ISSUE: Permit to Demolish (partial) and Certificate of Appropriateness for alterations (addition)

LOCATION: Old and Historic Alexandria District
729 South Pitt Street

STAFF RECOMMENDATION

Minutes from the July 3, 2024 BAR Hearing:

Figure 2b. Updated plans for the rear (west) elevation.

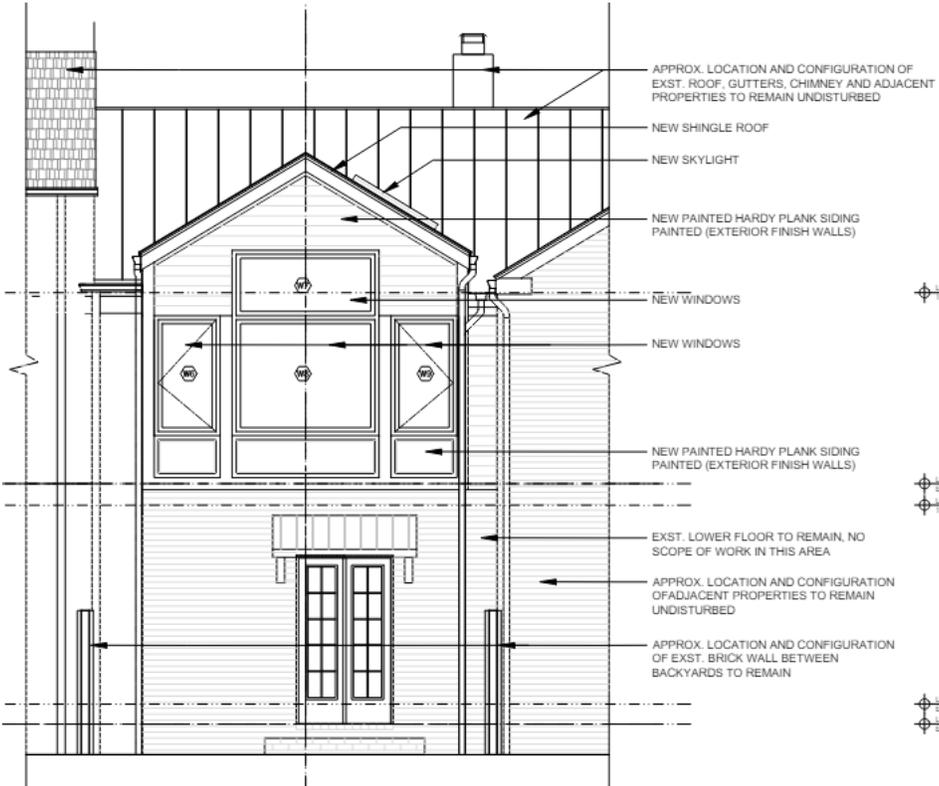
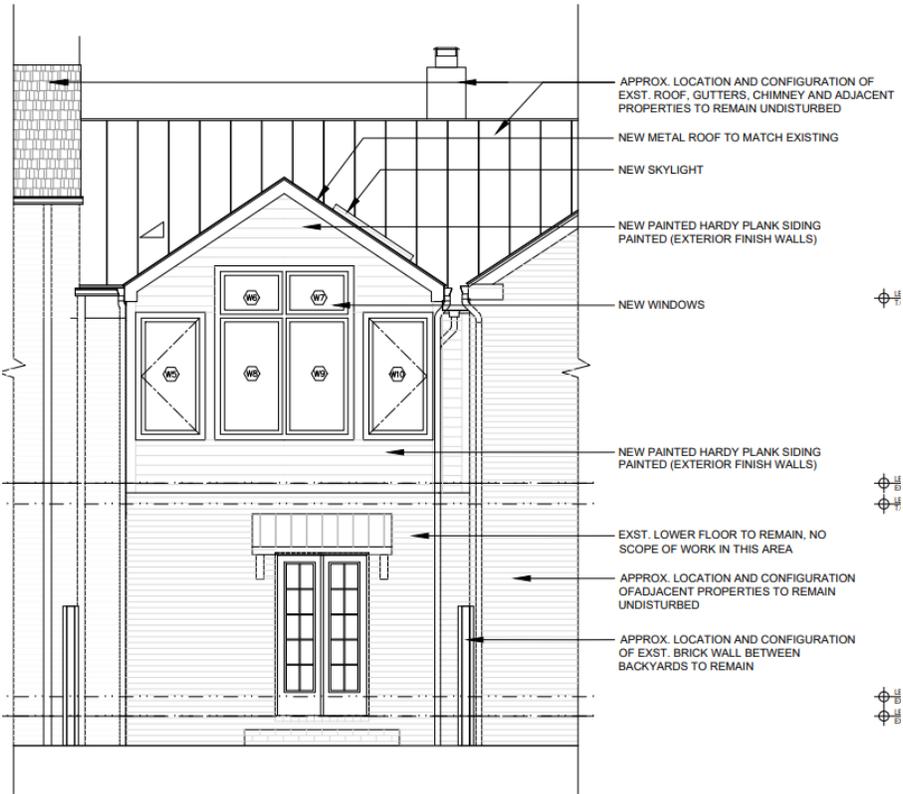
Figures 2a and 2b on the next page show the original and updated plans for the west elevation of the addition (the rear, facing the alley). Staff makes note of the following updates to the west elevation since the last hearing:

- The applicant has clarified that the new roof material will be metal, not shingles.
- The Board raised concerns that the roofline of the addition, as originally proposed, was incongruous with the existing roofline and would cause water drainage issues. In the new plans, the roofline of the addition has been lowered to be more symmetrical and in line with the existing roof.
- The two center windows have been broken up into four smaller windows to reduce the massing.
- The three siding panels below the windows have been removed to create a more flush siding appearance.

Figure 3b. Updated plans for the side (north) elevation.

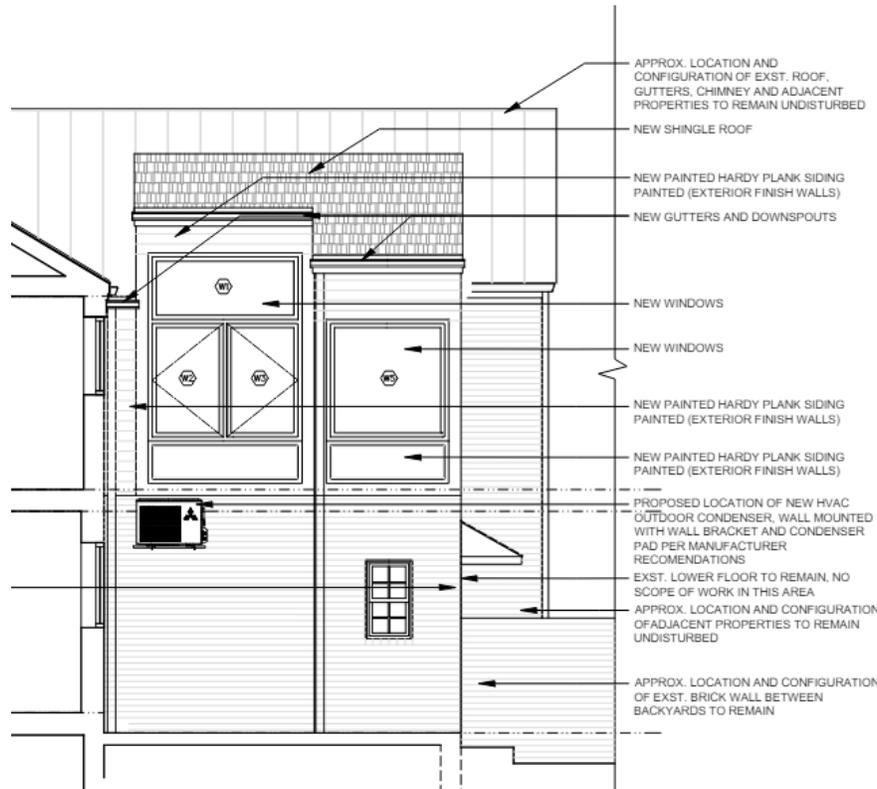
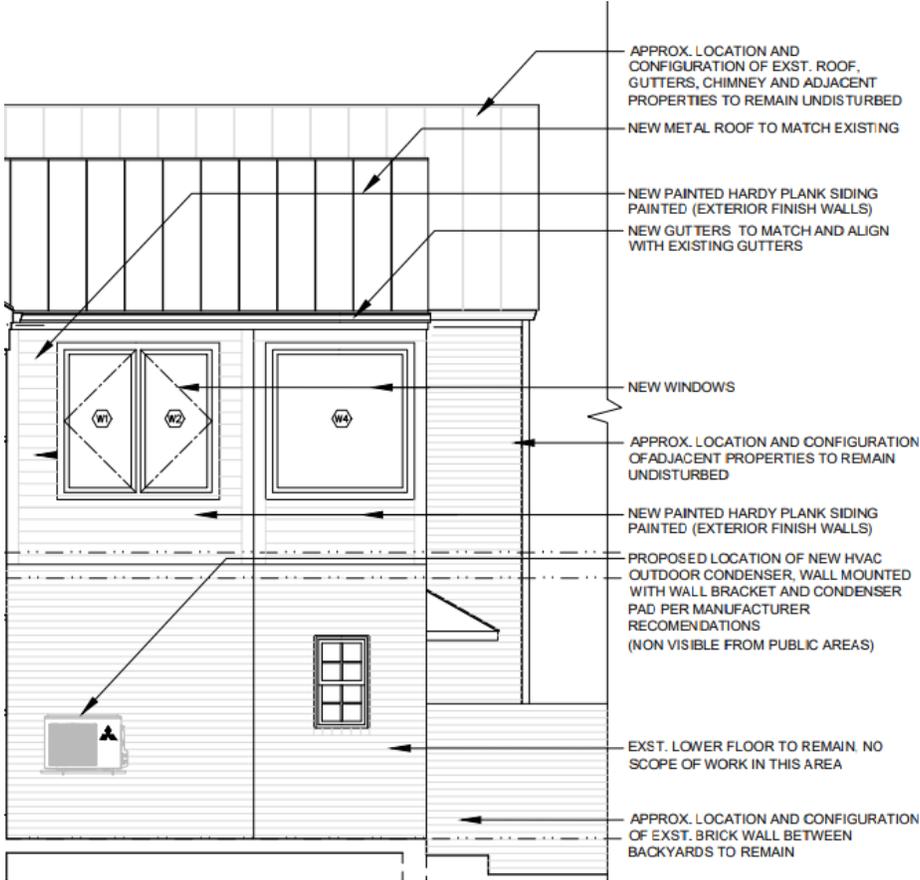
Figures 3a and 3b below show the original and updated plans for the side (north) elevation of the addition. Staff makes note of the following updates to the north elevation since the last hearing:

- The applicant has clarified that the new roof material will be metal, not shingles.
- The Board raised concerns that the roofline of the addition, as originally proposed, was incongruous with the existing roofline and would cause water drainage issues. In the new plans, the roofline of the addition has been lowered to be more symmetrical and in line with the existing roof.

- A Board member said that the original plans had too many windows on the north elevation and it was not sympathetic to the existing structure. The updated plans have removed the top-most window to be less visually overwhelming and more symmetrical.

- The two siding panels below the windows have been removed to create a more flush siding appearance.
- A Board member said that the proposed HVAC condenser unit should be moved to better align with the window. However, staff notes that the unit will not be visible from the public right-of-way and thus is not under the Board’s purview.
